Municipality of Anchorage

Date: November 6, 2017
To: Planning and Zoning Commission
Thru: Hal H. Hart, AICP, Planning Director *HHH*
From: Long-Range Planning Staff
Subject: Case #2017-0110, Proposed R-3A District
Planning and Zoning Commission Issues from October 9, 2017 Public Hearing

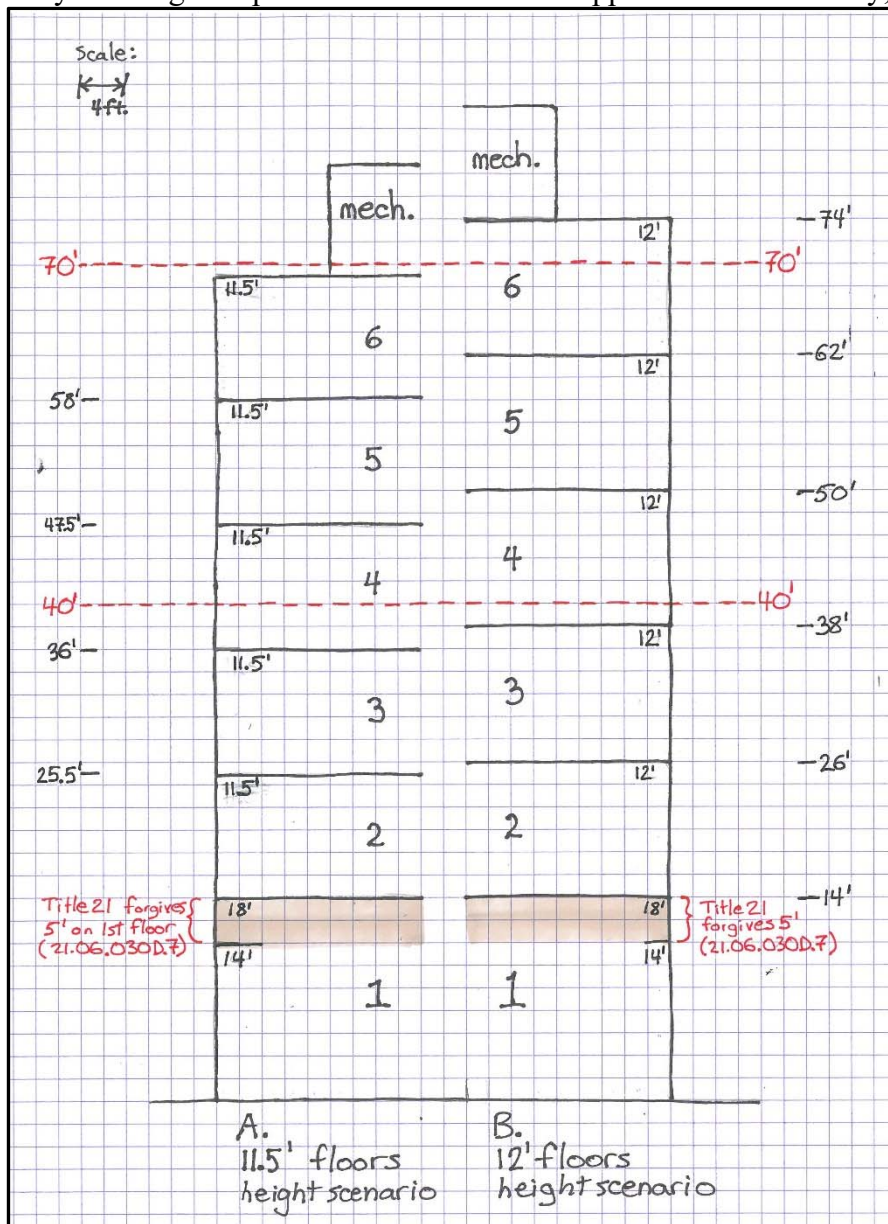
ISSUE #3. *Is it possible to alter the by-right height standard of the R-3A from 40' in the current draft to 48-50', with the intent to allow by-right four stories with a 14-foot first floor ceiling and 12' floor-to-floor heights on the residential floors, instead of the recommended three stories.*

The Commission noted that the fourth story is the least expensive to build using wood construction without a concrete/steel podium. It will support more R-3A development if four story buildings are practical and easier to be approved. Additionally, some public testimony

considered a three story building to be infeasible under a 40' building height, given current construction costs and construction industry trends for 11'-12' floor heights. The current by-right height of 40', it was argued, will negatively impact the likely use of this district.

Response: The recommended height provisions in the current draft already allow a three-story structure by-right, and a four-story structure through administrative site plan review by adding one public benefit bonus feature from the seven menu choices in subsection H.2.g. It already allows for a 14' or taller first floor and up to 12' stories on the residential floors:

As the illustration above indicates, the 40' by-right allowable height

accommodates a three-story building, even if it is mixed-use with a 14-foot tall first floor and has 12' tall upper residential floors, with height to spare. If the developer wishes to increase the height of the commercial first floor, Title 21 forgives an additional 5' of first floor height, as provided in the generally applicable height measurement rules in Section 21.06.030D.7., *Height*

1. Retain the maximum height allowed by-right of 40' (which already builds in flexibility for 12' residential story heights plus an additional 5' of increased first floor height), and the administrative bonus system allowing a fourth story up to 50' with the addition of one public benefit feature out of seven possible menu choices.
2. Amend the first line of H.2.g. subsections i-vii Building height increases ~~from 40 feet of additional height~~ and replace with one story of additional height.

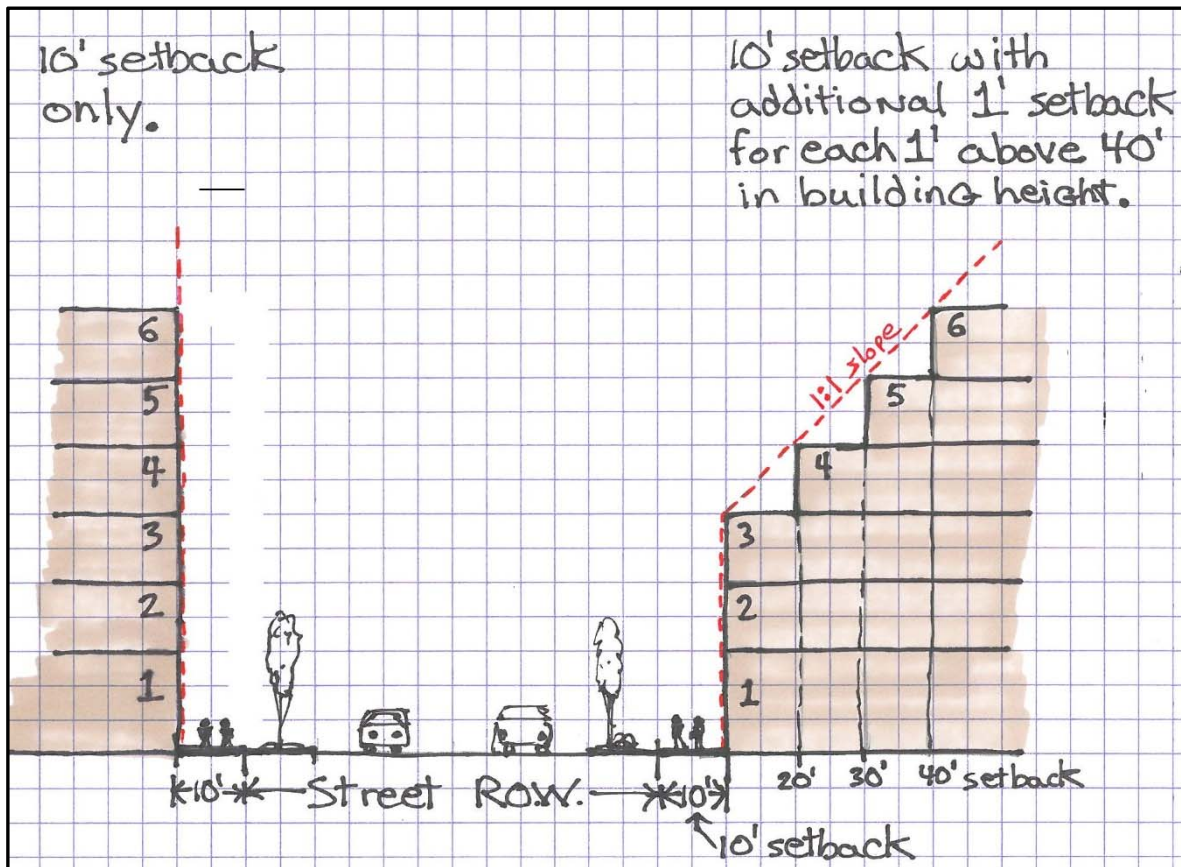
ISSUE #5. *A Commissioner requested that consideration for R-3A sites be added to areas of the Bowl adjacent to major trails and greenbelts including the Coastal Trail and Chester or Campbell Creek greenbelts.*

The Commission noted that this zoning district might be appropriate to and could enhance the Bowl's larger greenbelt trail areas, including Chester Creek, Campbell Creek, and the Coastal Trail. Could the district be considered appropriate in these areas?

Response: Staff agrees with this concept. In fact, the majority of the larger sites designated as potential R-3A District sites by the 2040 LUP are located along the greenbelt system. Many of the properties adjacent to the Bowl's larger greenbelts and larger trail corridors already have the capacity for higher residential densities. Many of these trail facilities are next to R-3 districts, which allow existing higher densities. The 2040 LUP designates other areas along greenbelts to higher density residential designations, to allow for potential rezonings to R-3 or R-4.

Not all areas along trail corridors that merit higher density are necessarily candidates for mixed-use commercial as well. In order to consider future rezones of R-3A to locations near larger greenbelts and trails, an amendment to the 2040 LUP would be required. Staff recommends adoption of the R-3A as a zoning district first, see how it is working, and include adding appropriate lands near trails and green belts as an amendment to the 2040 LUP after a thorough public process.

Recommendation: No changes to the ordinance at this time.
